RESPONSE TO NCSWS REVIEW COMMENTS SITE HYDROGEOLOGIC REPORT

JMN/CLEVELAND CONTAINER INDUSTRIAL LANDFILL
 CLEVELAND COUNTY, NORTH CAROLINA

Subject: **Response to NCSWS Review Comments**
Site Hydrogeologic Report
 JMN/Cleveland Container Industrial Landfill
 Cleveland County, North Carolina
 BLE Project Number J99-1307-04

PIEZOMETER NO. PZ-2ab

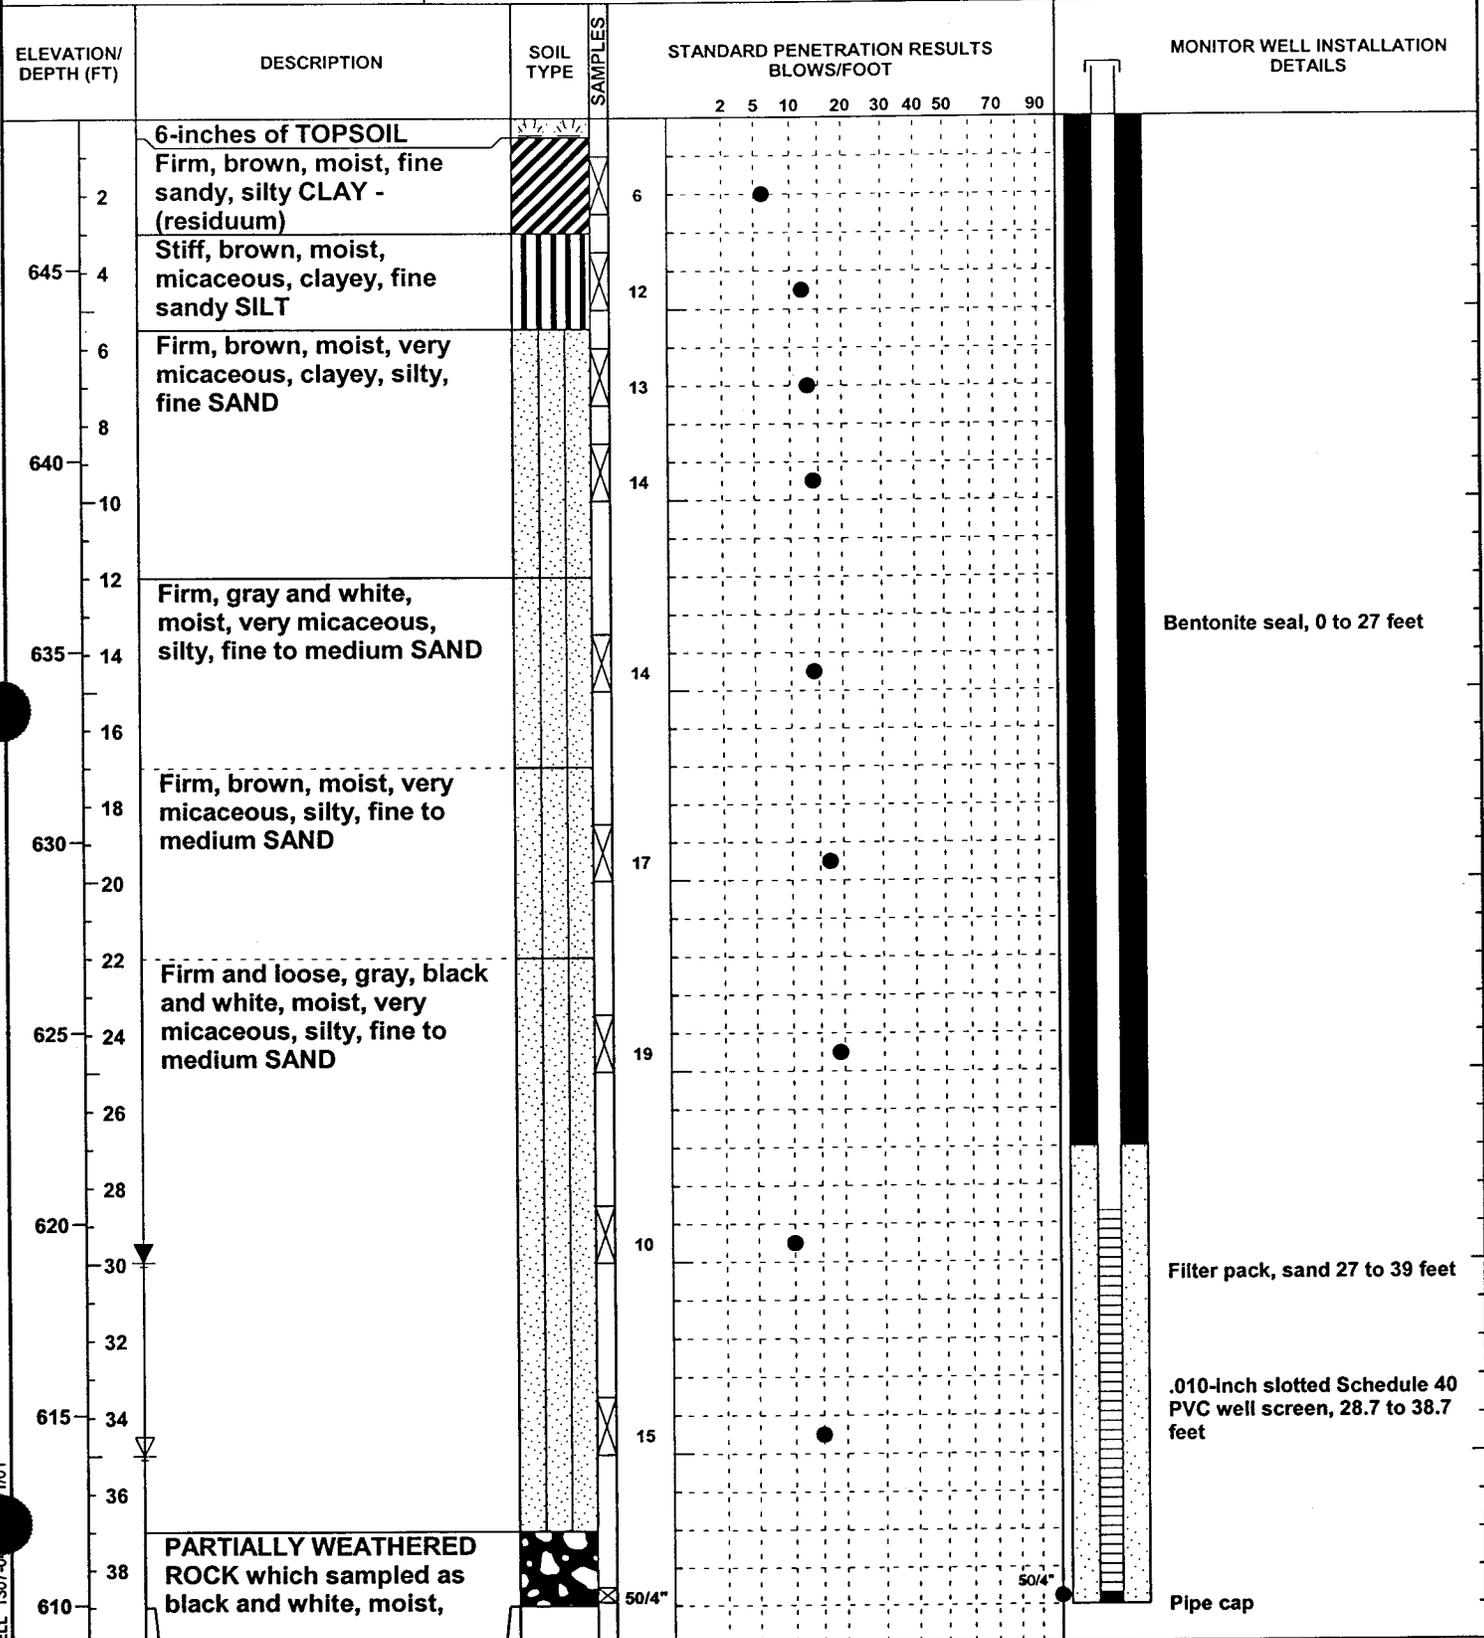
BLE conducted additional confirmation laboratory testing on two shallow soil samples from boring PZ-2ab. The Atterberg Limits test results identified the soils as CH and MH. The laboratory test results are in Attachment E, and will be added to the SHR (Table 3, Appendix E). Additionally, the text of the SHR has been changed to classify the shallow residual soils as CH (rather than CL), MH, and ML.

PIEZOMETER NO. PZ-3

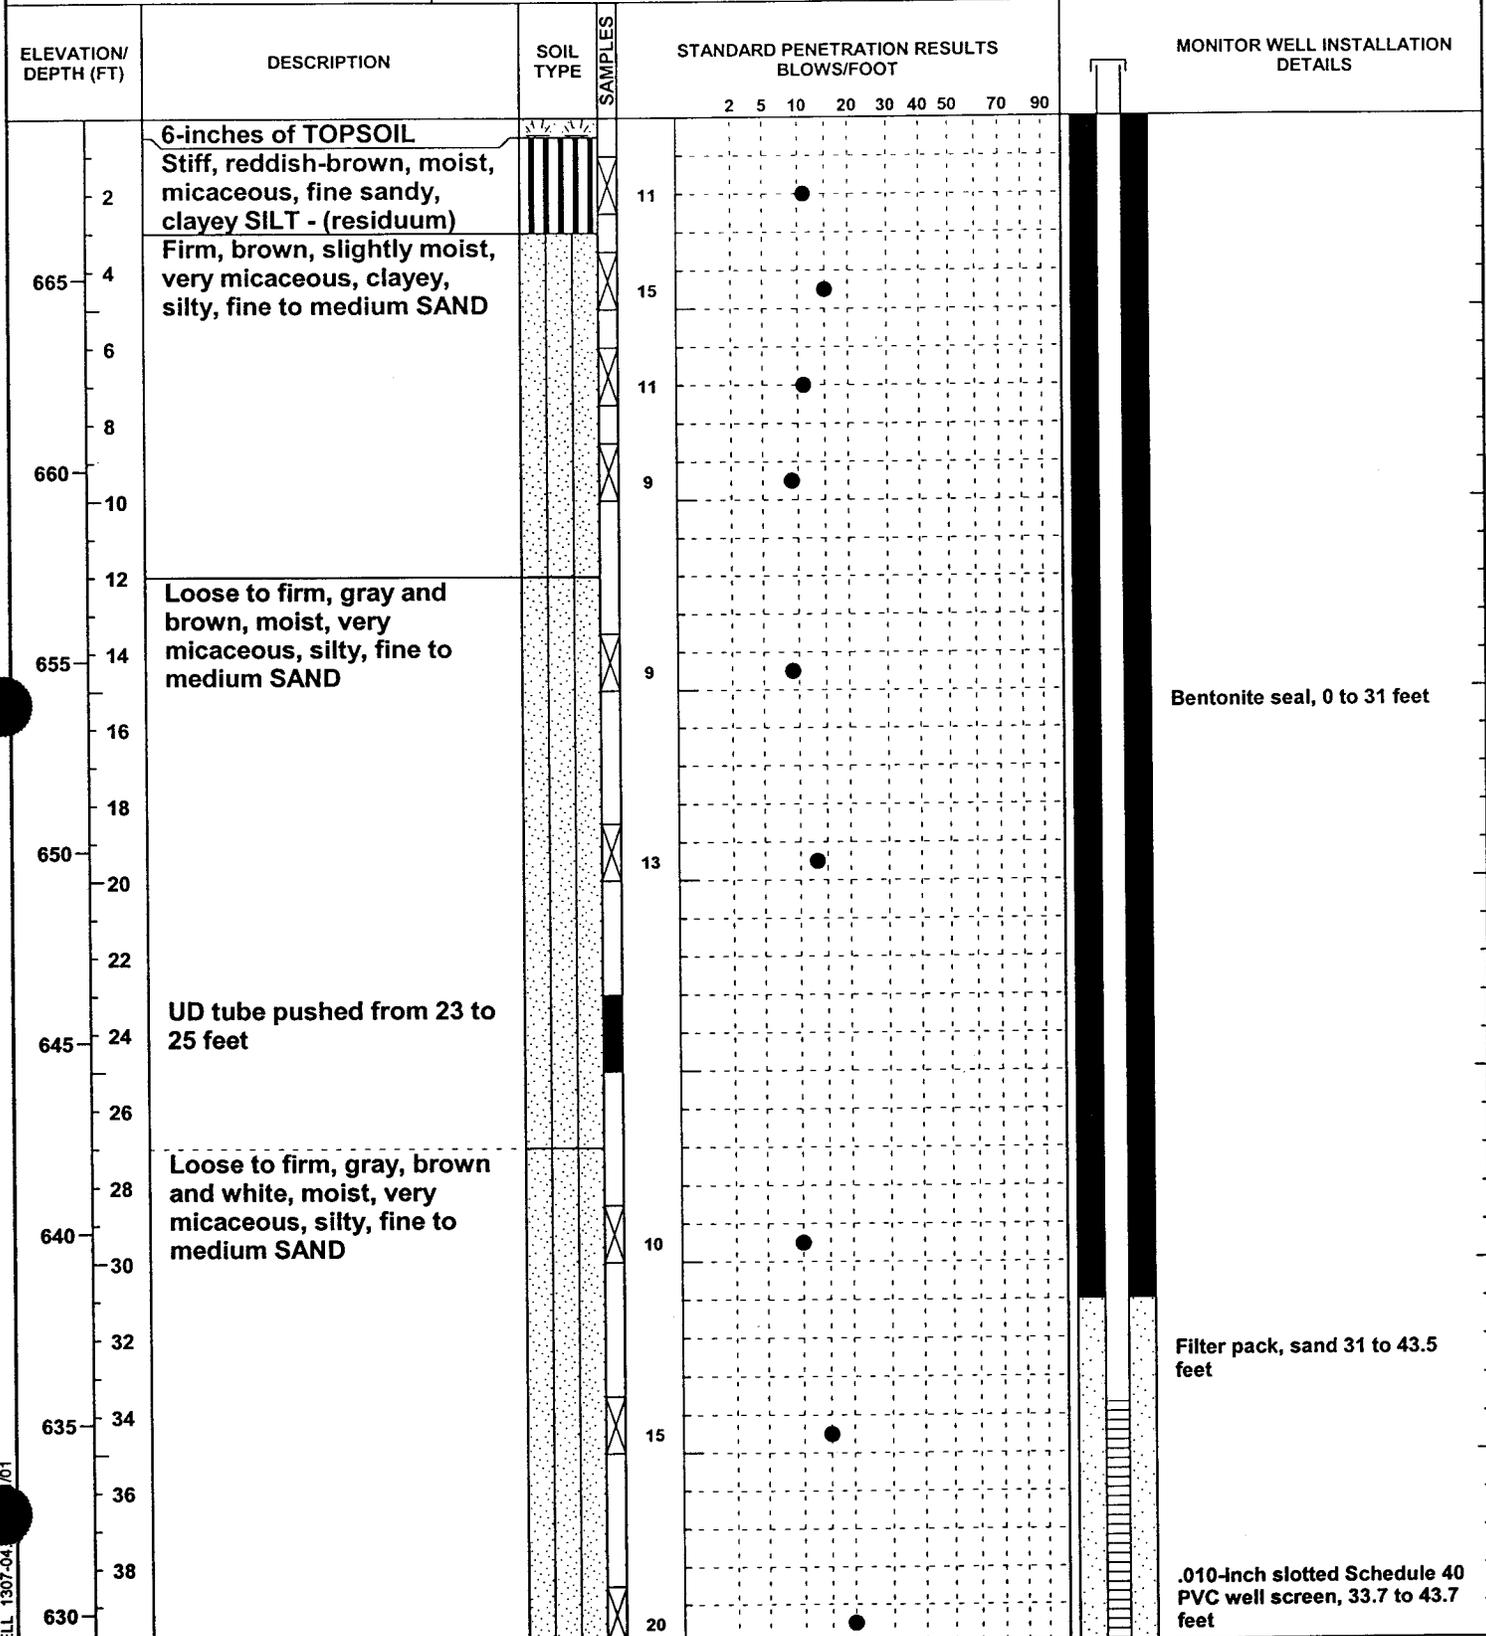
Why is the depth to water for PZ-3 reported at >43.98 feet for all measurements? Is the well dry? Submit an explanation of this.
